**Daniel Building Renovation for:
Midwestern State University
Wichita Falls, Texas**

BYSP PROJECT NO. 18071

September 24, 2020

TO: All Contract Bidders of Record

1 FIRST FLOOR UNDER FLOOR DEMOLITION PLUMBING PLAN
SCALE: 1/8"=1'-0"
0 4 8 16

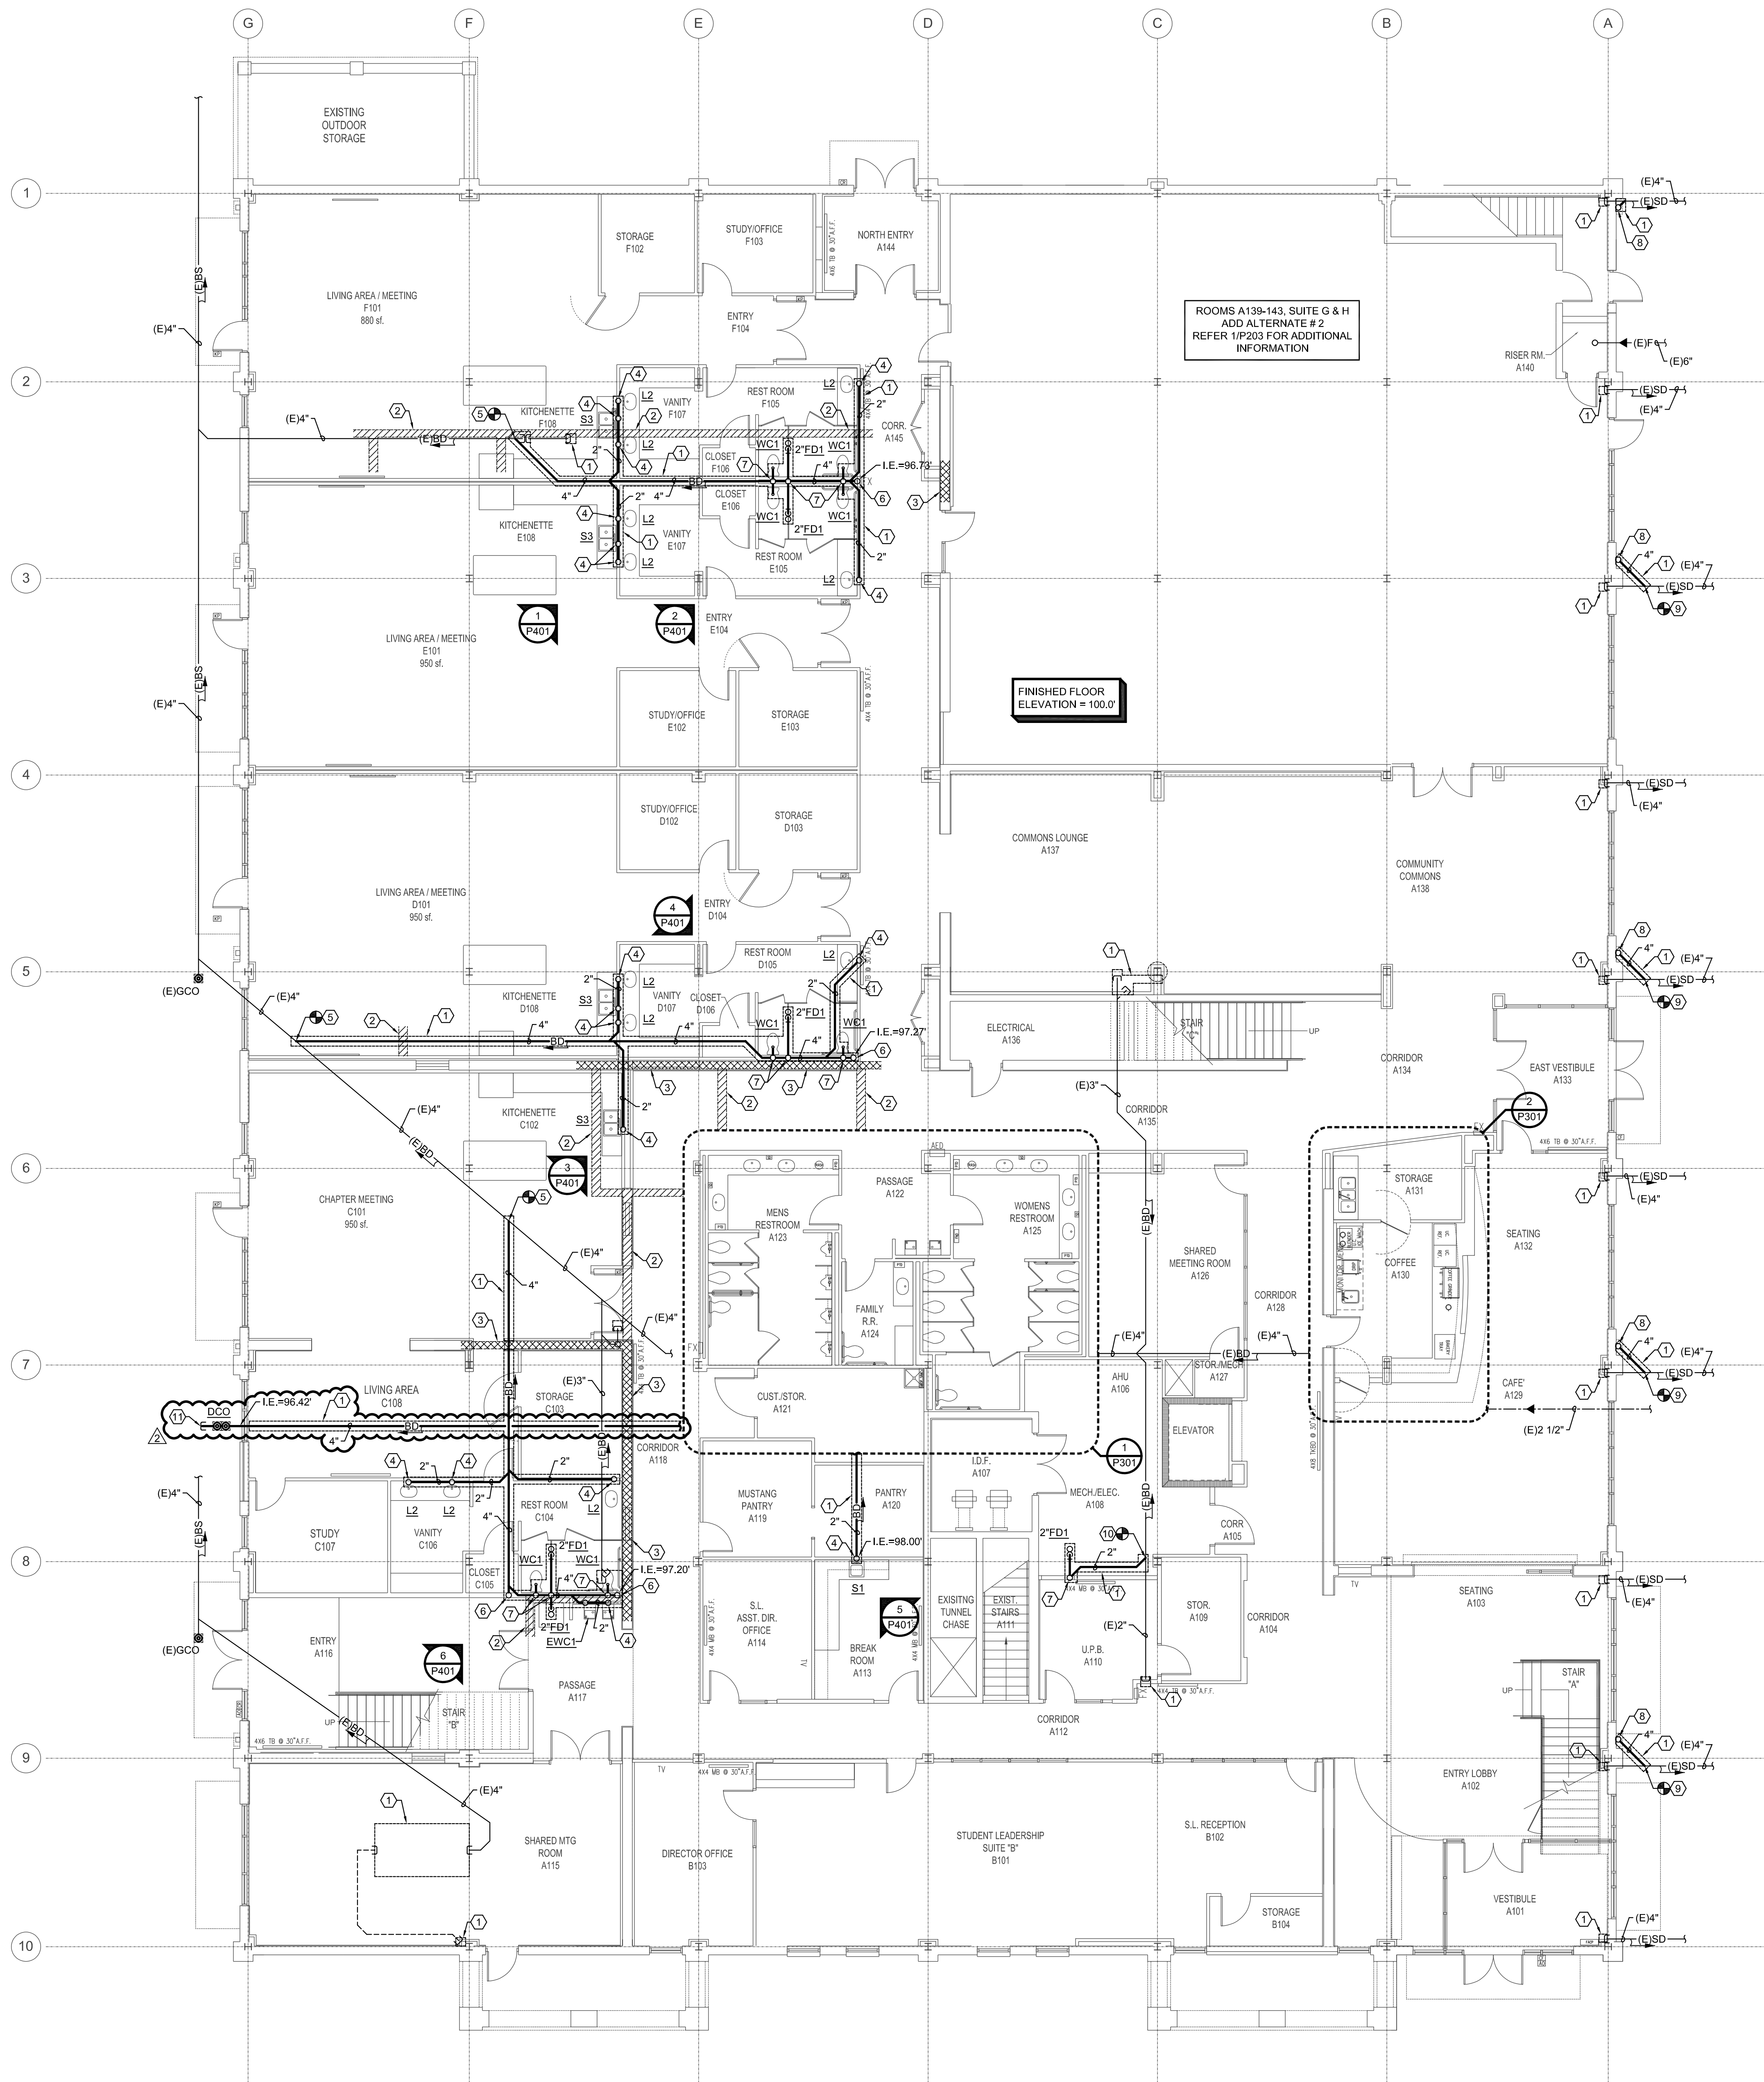
1. Added Saw Cutting for new under floor sanitary sewer from new Floor Sink (FS1).

1 FIRST FLOOR UNDER FLOOR PLUMBING PLAN
SCALE: 1/8"=1'-0"
0 4 8 16

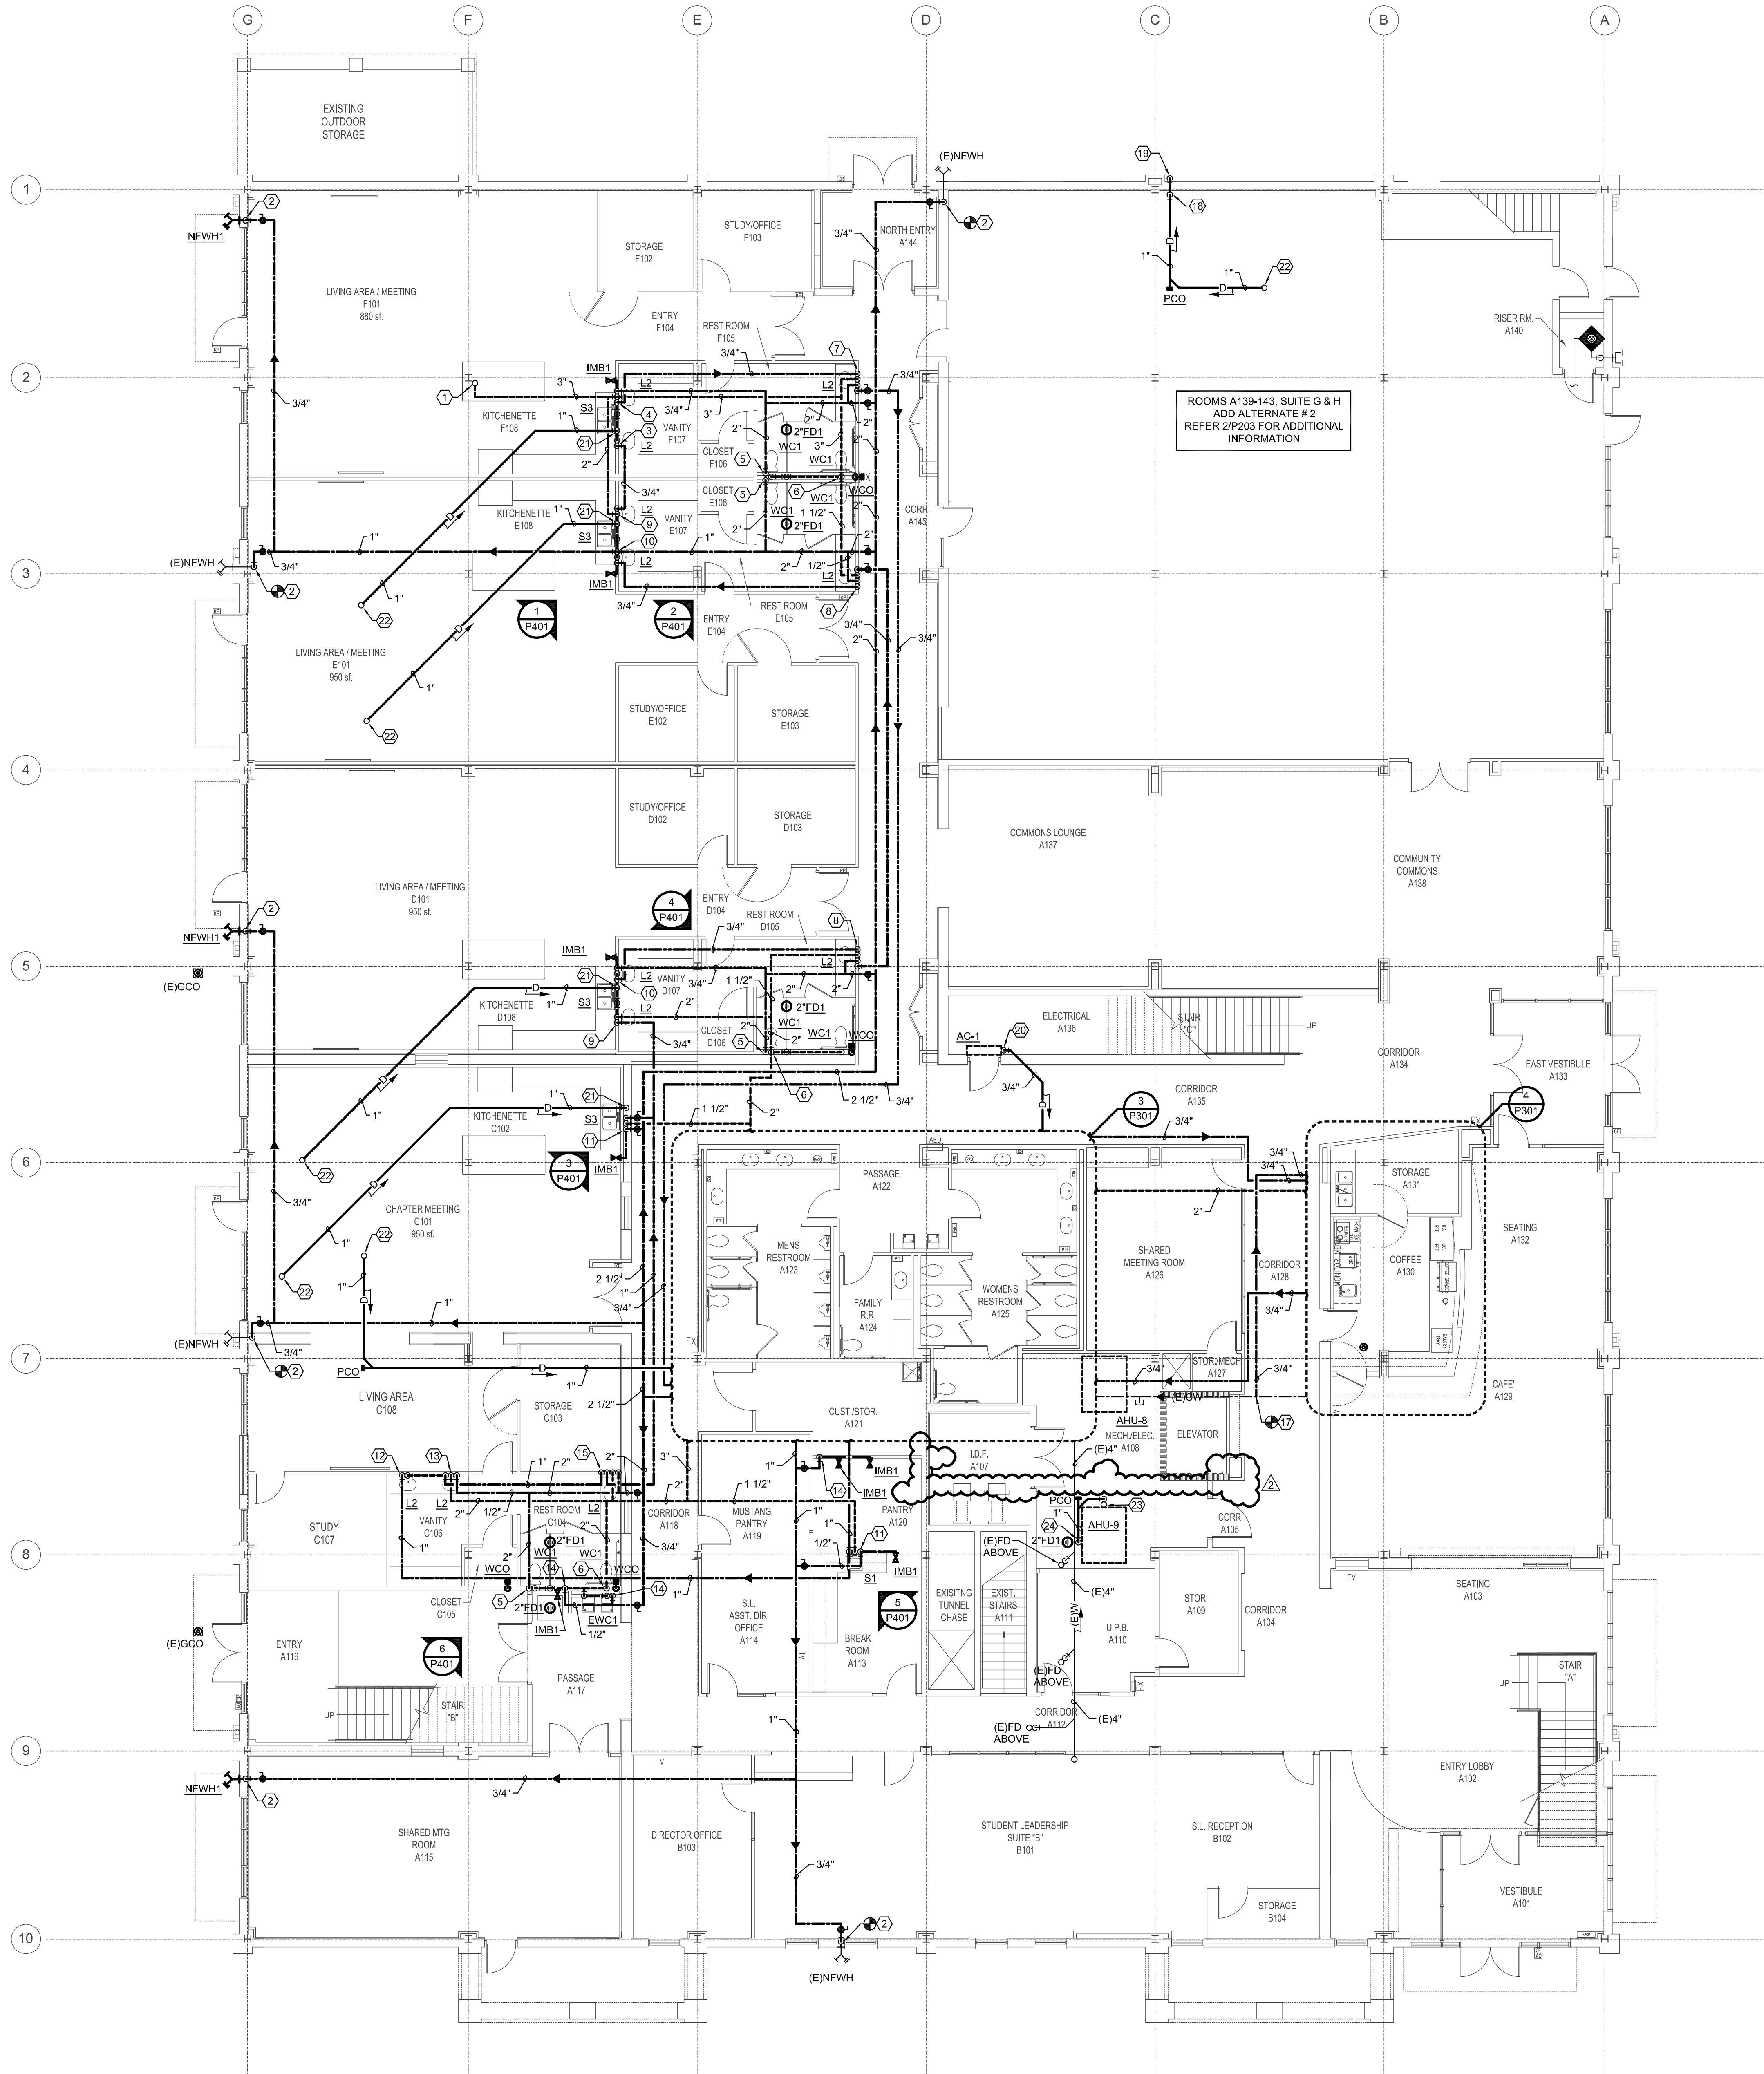
1. Added new under floor sanitary sewer from new Floor Sink (FS1).
2. Notes By Symbol: Added Note 11.
